Notice of Modification

Section 4.55(2) of the *Environmental Planning and Assessment Act 1979*

The development consent for the Crudine Ridge Wind Farm (SSD-6697), granted by the Planning Assessment Commission, as delegate of the Minister for Planning, on 10 May 2016.

APPENDIX 2 GENERAL LAYOUT OF THE DEVELOPMENT

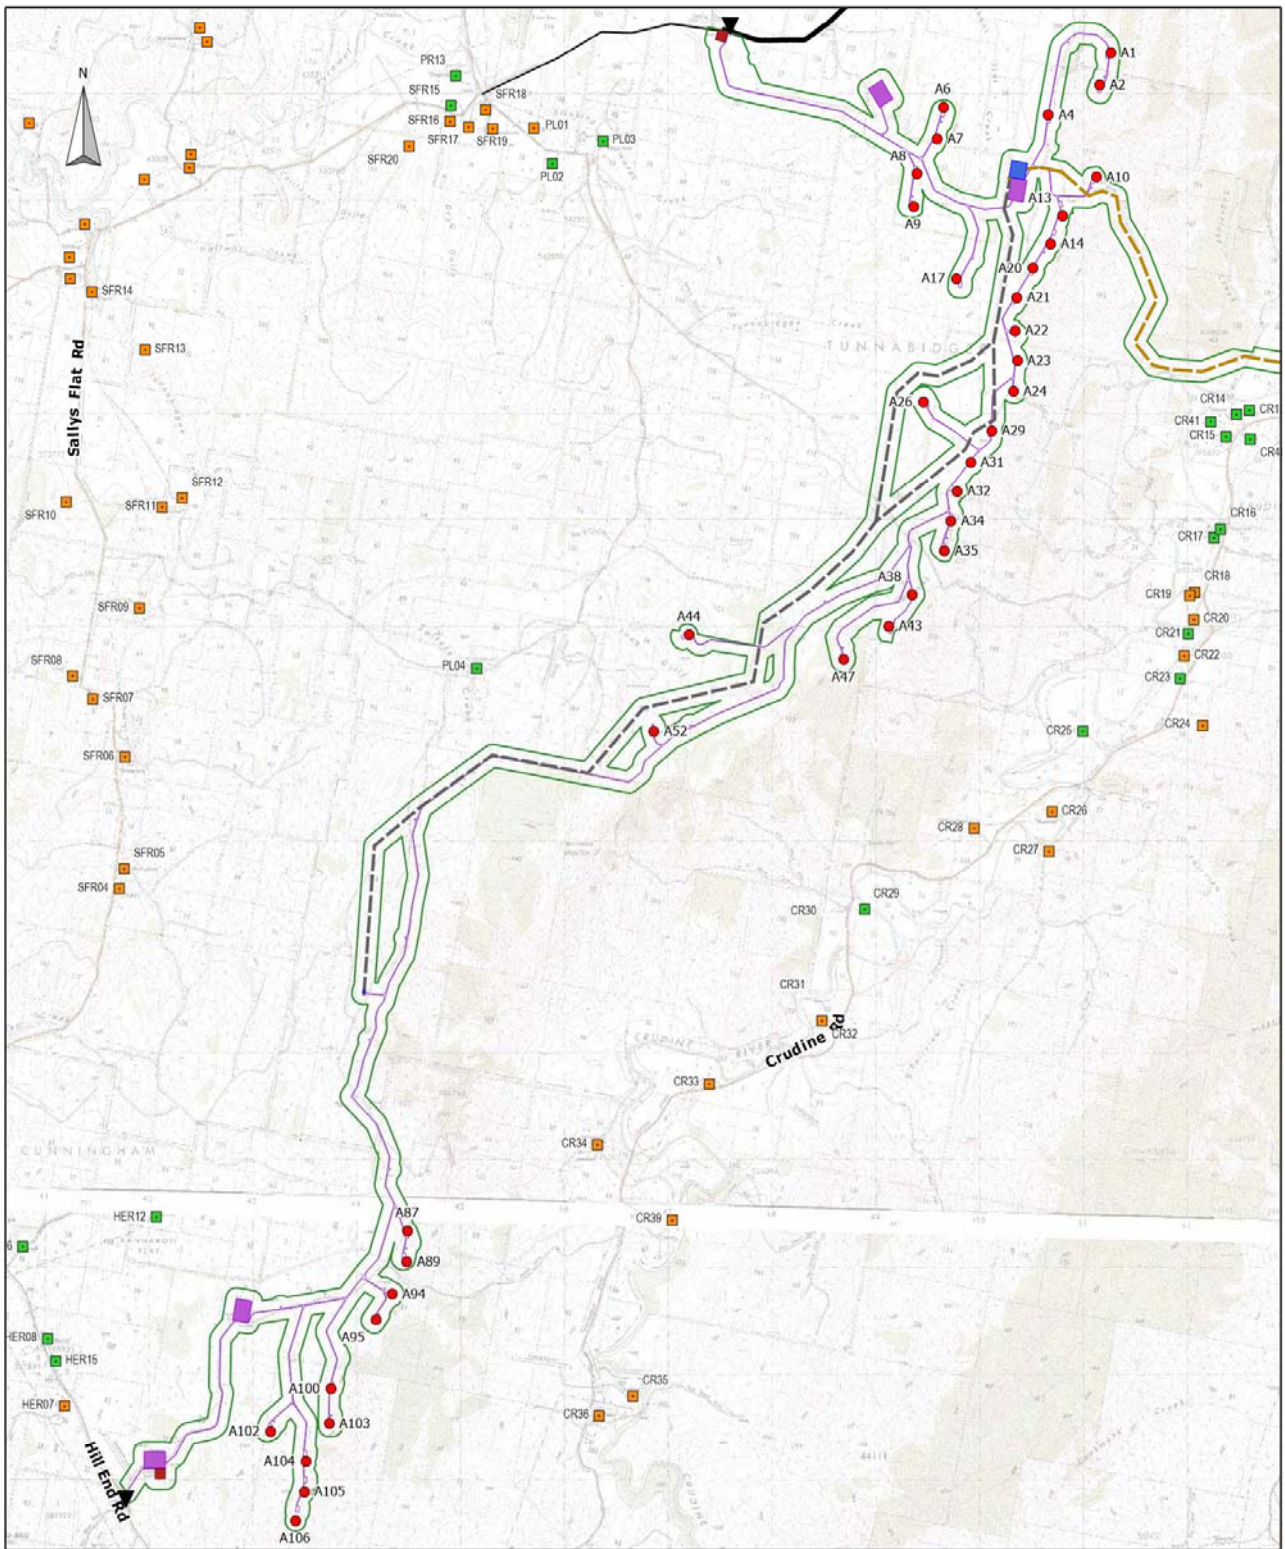
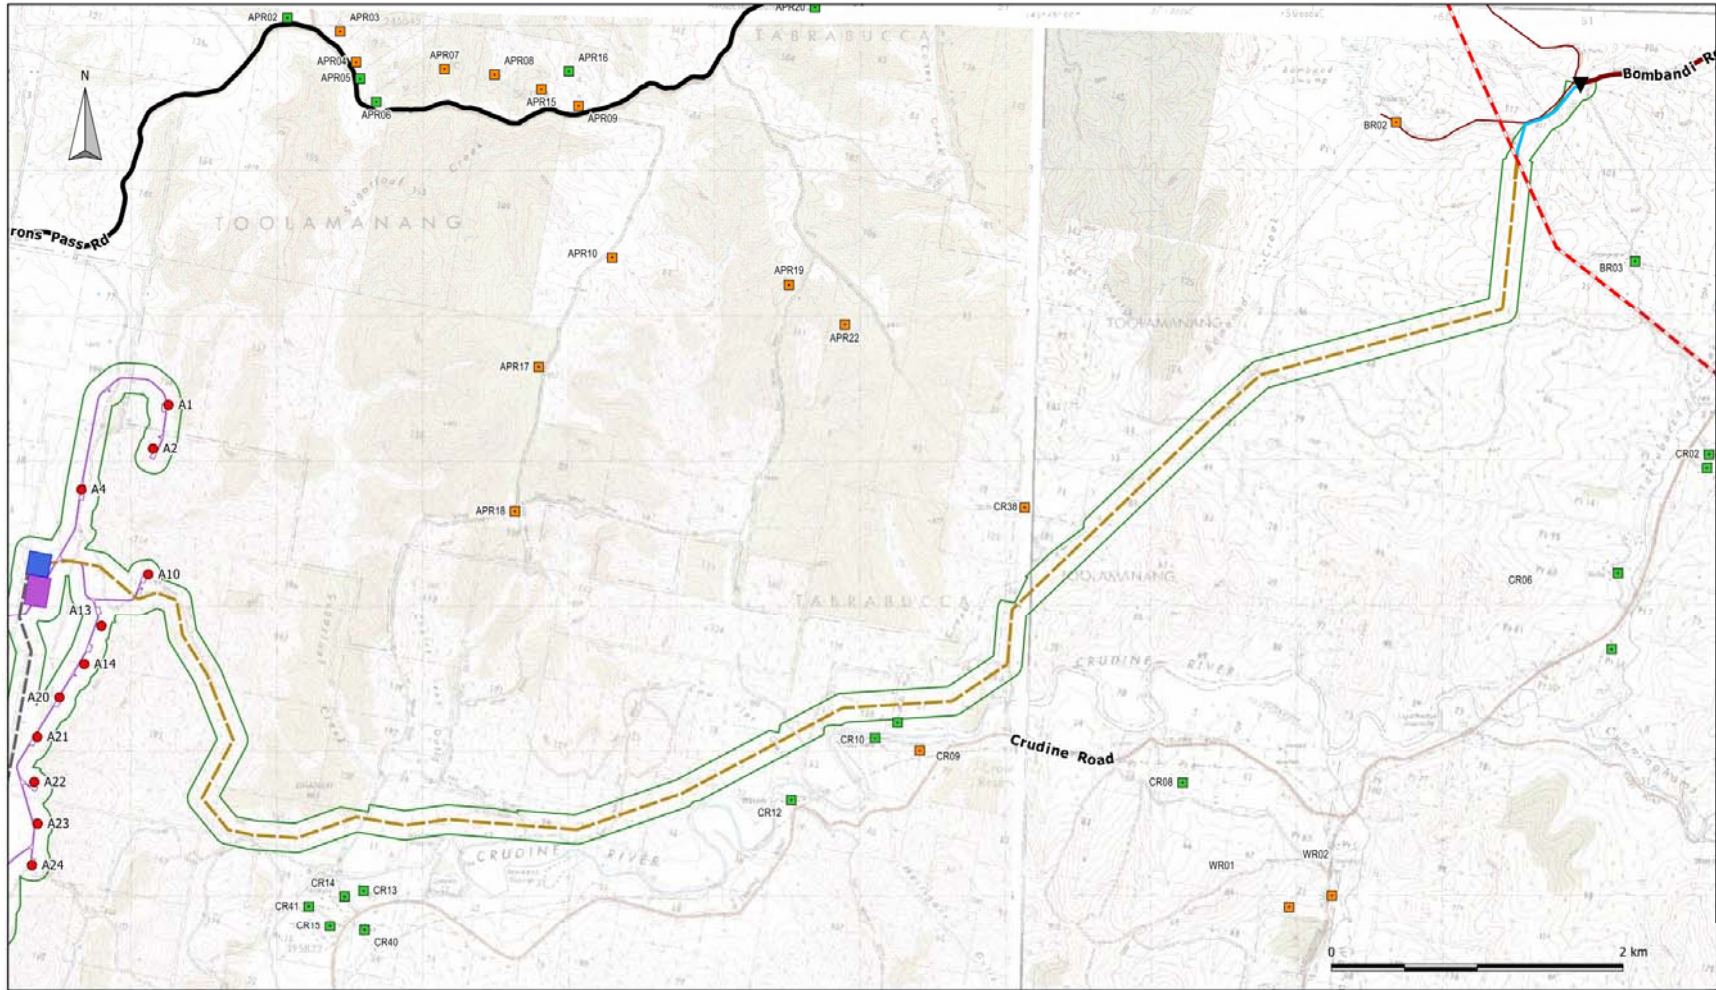
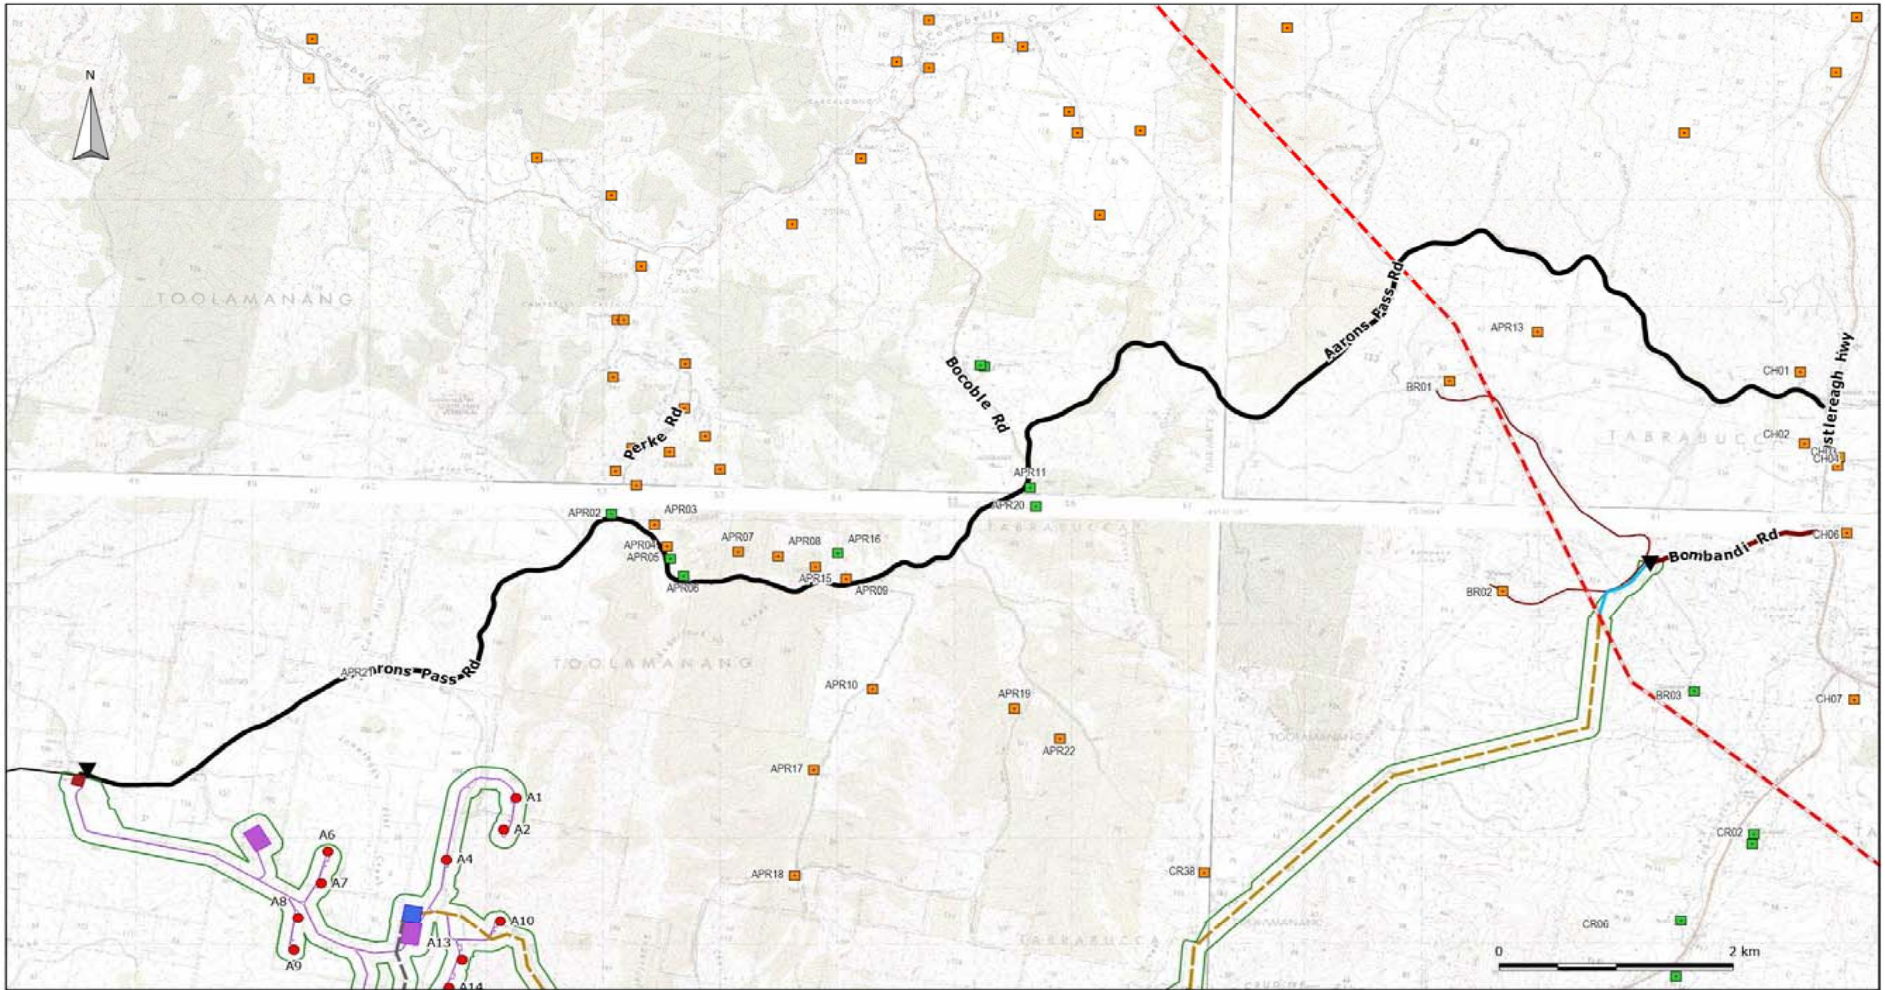
26. Delete Appendix 2 and replace with the following:

**APPENDIX 5
BIODIVERSITY OFFSET AREA**

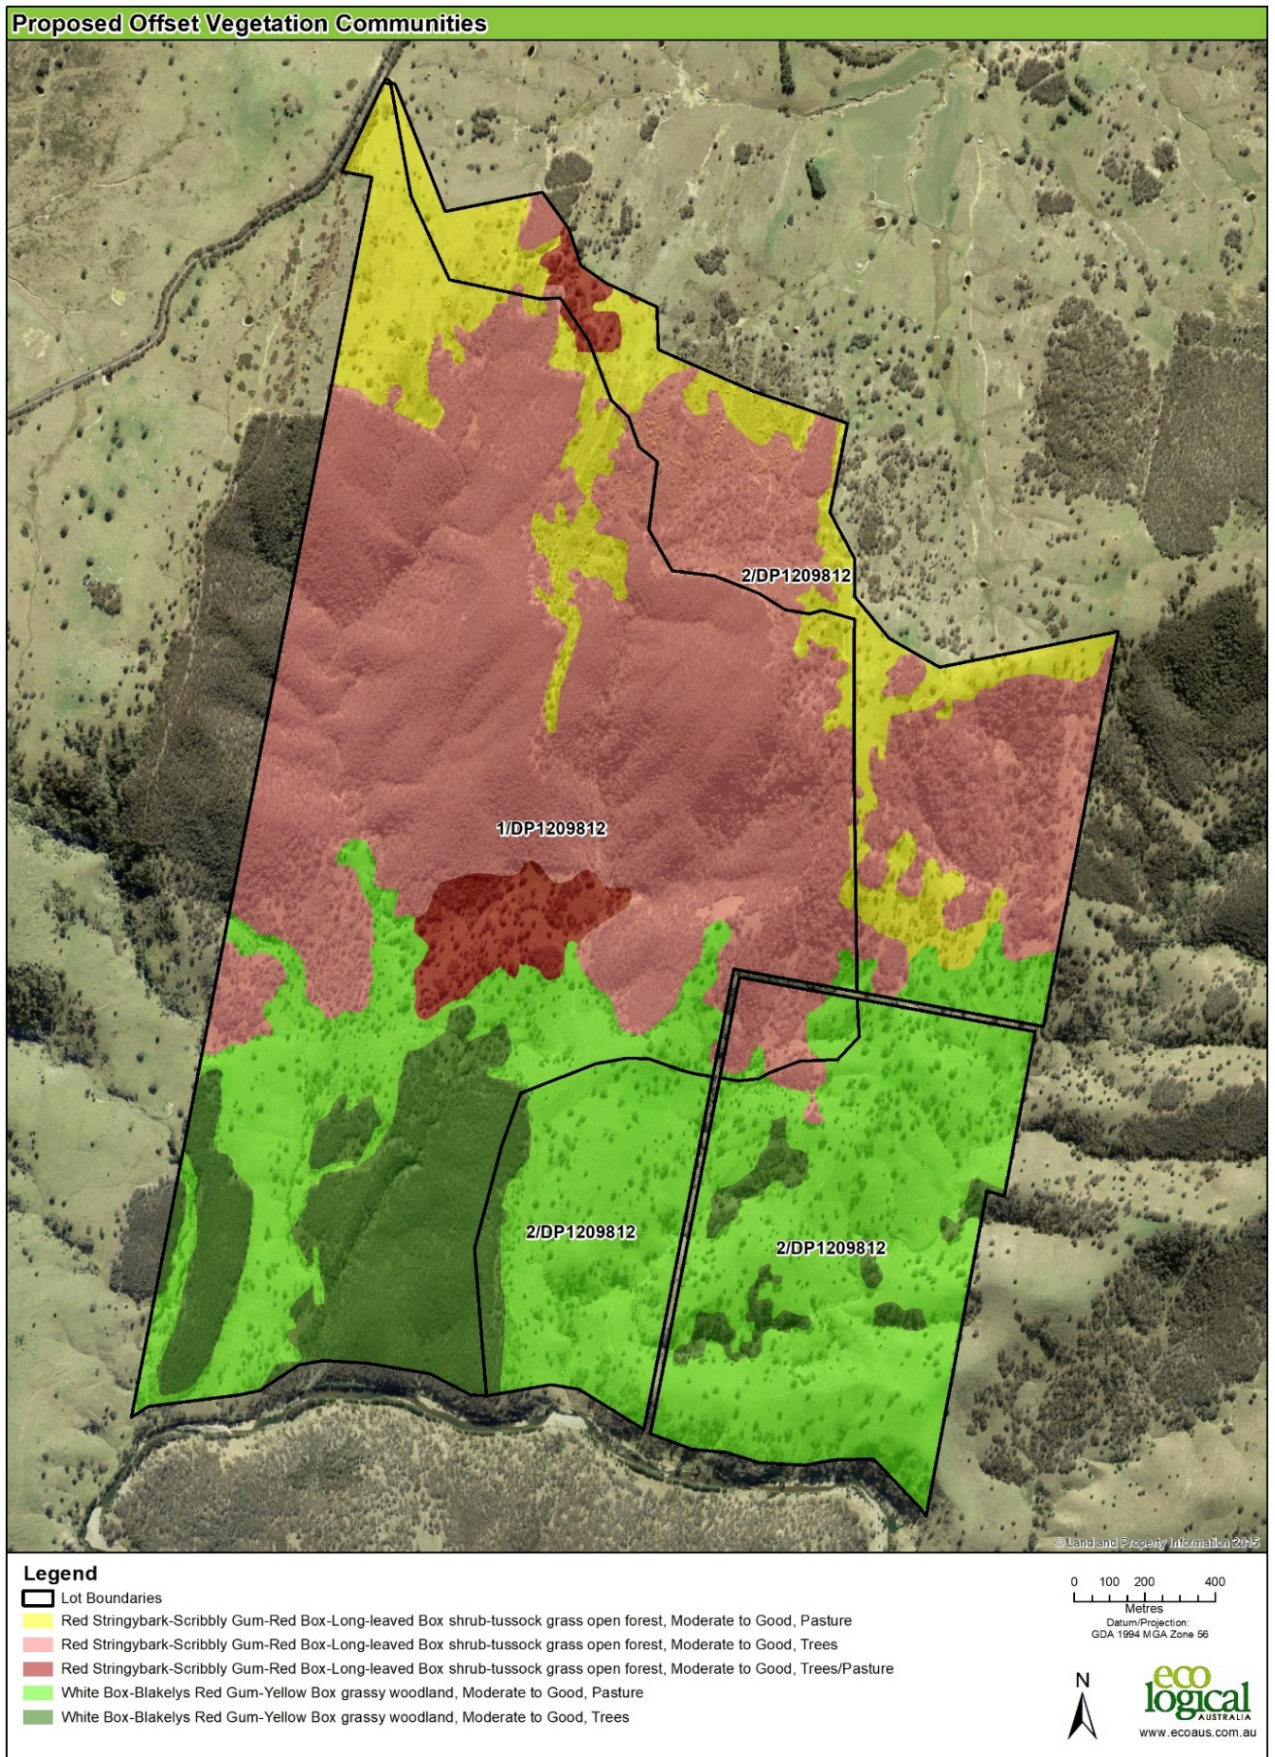
27. Delete Appendix 5 and replace with the following:
